MIDTOWN GREENWAY COALITION INFORMATION REQUEST

Xcel Energy

PUC No. E-002/TL-09-38

Information Request No. 29

Response to IR 29: Attachment 1; page 1 of 4

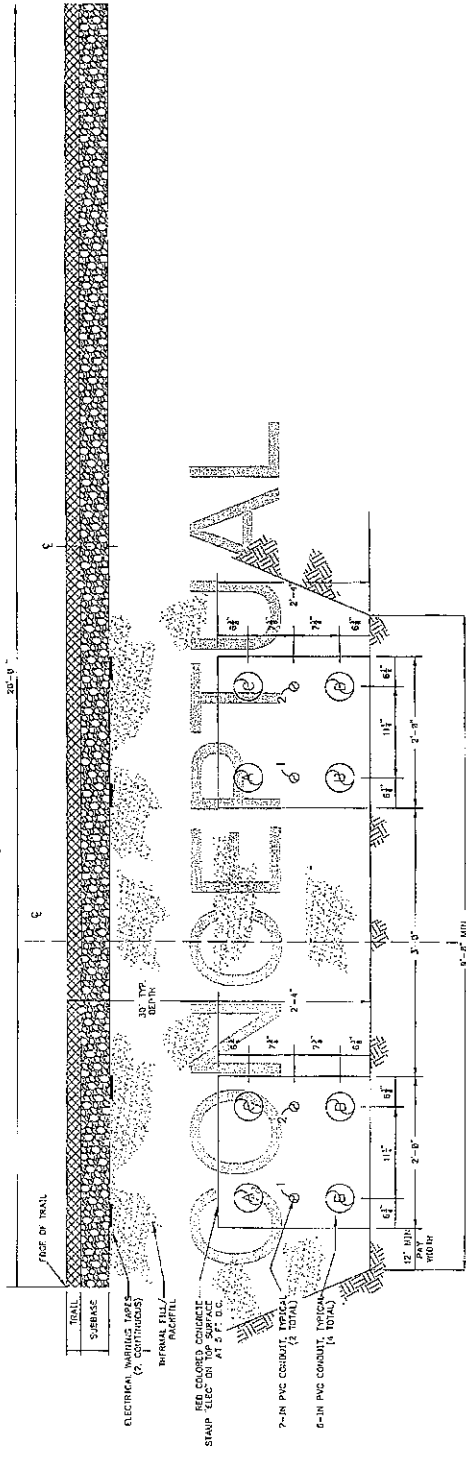
- C. For Applicant's Route A Underground – Design (referred to in Part A above) and any alternative Route A underground route alignments (referred to in Part B above), please provide a cross section drawing to-scale showing the placement of the transmission lines relative to the Midtown Greenway cycling and walking trails, the south Greenway shoulder, and other key defining features for each segment of the Greenway where the line placement would differ.

- C. See **Attachment 1**.
- D. For Route A, overhead construction, minimal closure to the trail is anticipated. Where the underground route crosses the bike path, closure would be limited to a short duration, these sections would be treated like road crossings and done at times of minimal traffic. For the underground alignments in Route A, where the underground route parallels the bike path, it is anticipated that only partial lane closures would be needed. Underground construction would likely be done in short segments of 100 to 150 feet. Two segments are opened at once to allow for adjustment and alignment of the line; therefore 200 to 300 feet of the trench would be open at one time. It typically takes one to two days to open a segment, prepare the segment for the duct bank, pour concrete and close the segment. To ensure that bicycle traffic is not interrupted, it is anticipated that a temporary path and extension of the trail will be created elsewhere in the trench or adjacent streets.
